Service Bulletin

Subject: Mag Timing Housing- Dowel Pin

Date: 02/23/2017

This Service Bulletin informs owners and operators of aircraft equipped with Electroair 6-cylinder Mag Timing Housings (MTH), Part numbers EA-10000 or EA-12000, approved under Supplemental Type Certificate SA03286CH.

Figure 1: Modified MTH

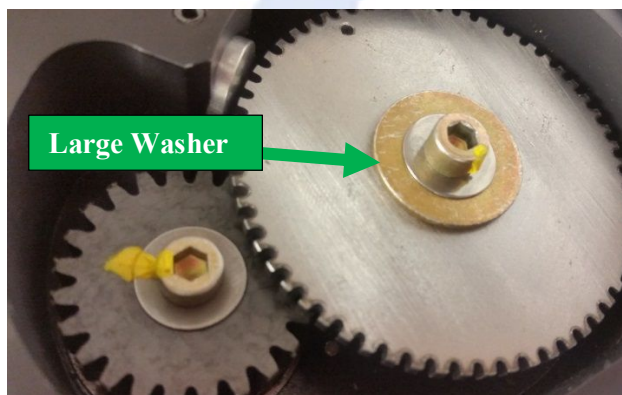
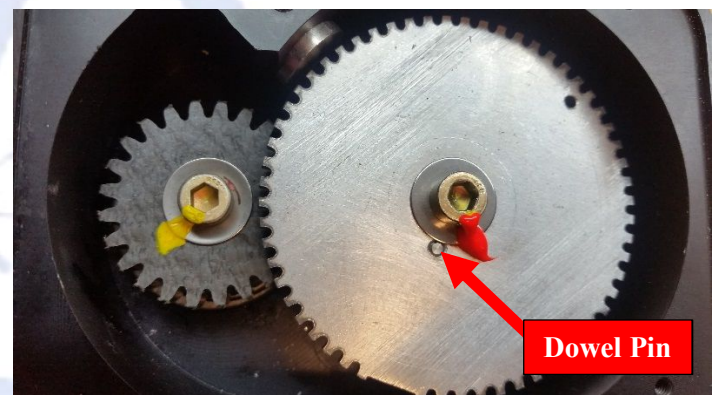
Owners and operators of aircraft equipped with the referenced EA-10000 or EA-12000 6-cylinder Mag Timing Housings (MTH) can inspect the MTH to see if it has already been modified. To check for the modification, first remove the bottom cover of the MTH unit. Use caution with the screws, because those are brass screws which can easily be cross threaded. Once the cover has been removed, simply visually inspect the top of the trigger wheel. If you see a large washer under a smaller washer and screw, then the MTH unit already has been modified (Figure 1). If you see only a small washer and the dowel pin, then the MTH has not been modified (Figure 2).

If your unit (Figure 2) contains only a small washer, and you can see the dowel pin, then your unit should be returned to Electroair for service and modification.

What Electroair will do: Affected serial number Mag Timing Housing (MTH) unit owners should contact Electroair and schedule the modification. Units that have NOT been modified with the larger washer may be returned to Electroair for modification/alteration to be configured into the latest design. There will be no charge for this modification.
